Mr. Haji Abdula Karani is informed that the plan submitted by him for building a bungalow

on plot No. 10 + 11^B Survey Sheet F11 situate in Street, Civil Lines

—PLAN OF PROPOSED BUNGALOW WITH OUTHOUSES.—

— ON PLOT N^o 10 & 1A - SHEET N^o F.I. —

—BLOCK PLAN—

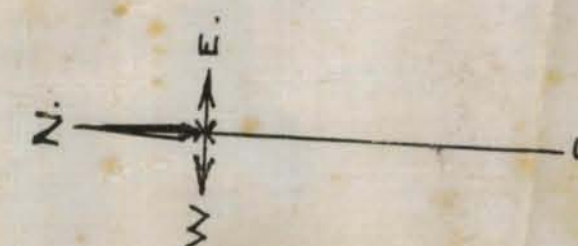
Submitted with report
passage between the Sewage
Dr. & the stable block
must at least be 5 ft.

With reference to his application dated 28th November 1920, with a plan for the proposed additions & alterations for the buildings on plot No. 1 & 1-2, F-11 Civil Lines Quarter, Mr. Hajji Abdool Karoon is informed, the out-houses must be arranged to run from East to West.

The stables must therefore be so arranged.

~~With ref. to this there is no objection~~
Stables Blocks running from
North to South must be deleted.

Remarks Sir, I beg to report that the out houses
should run east and west and not north
and south which should be deleted when
permission is given for the same.

The outhouse have been
shown 5 ft apart.

With reference to your
No. L.S. 7011 of 10th inst. I beg to
resubmit herewith the plans of
building on plot No. 10 & 13 Sheet
4-11. Civil lines & to state that
the Stables have now been arranged
to run from East to West & therefore
request that the plans may now
please be approved.

— GROUND FLOOR PLAN —
(STABLES).

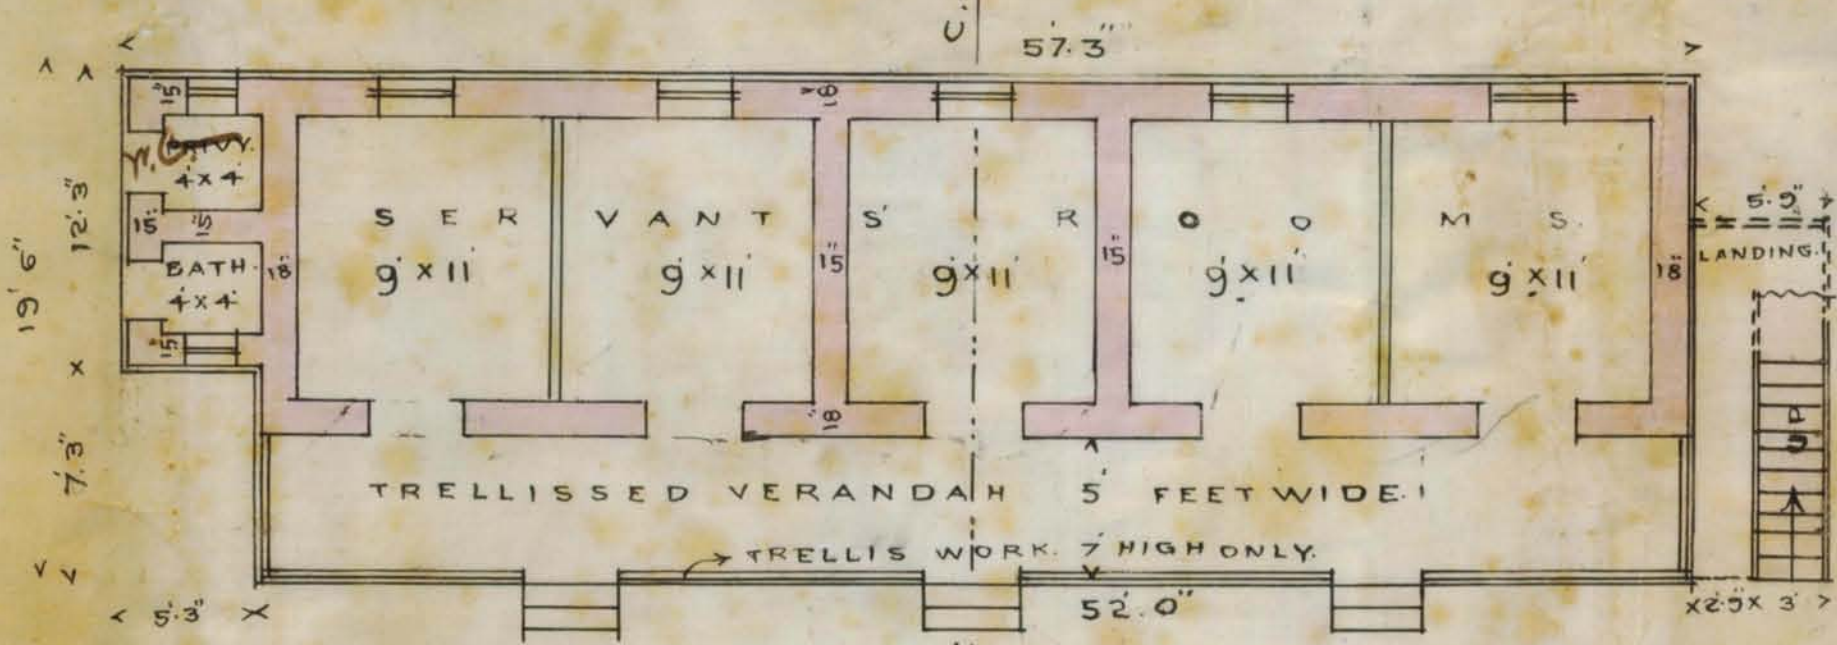
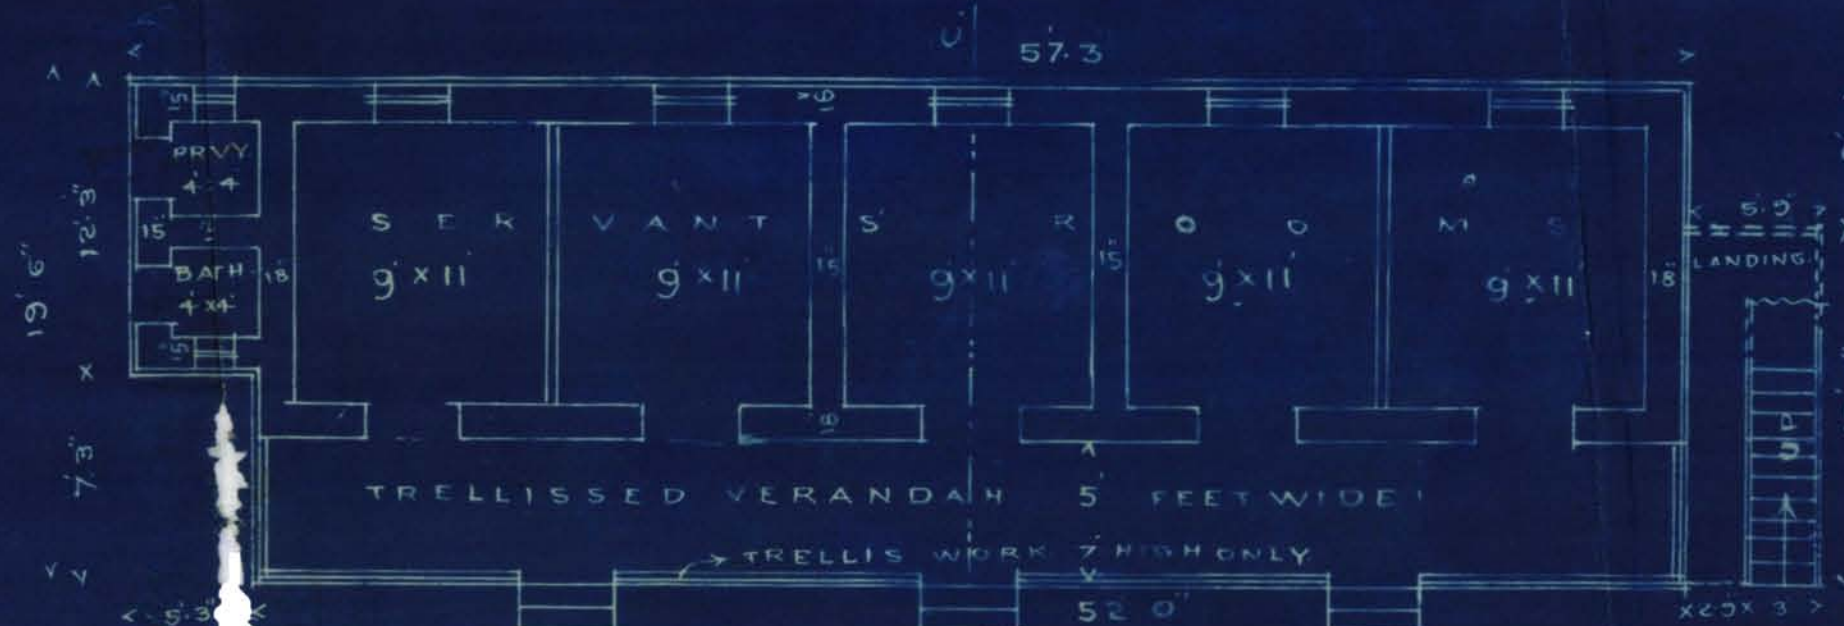
Informing that the out houses
must be arranged to run east and west.
The stables must therefore be so
arranged
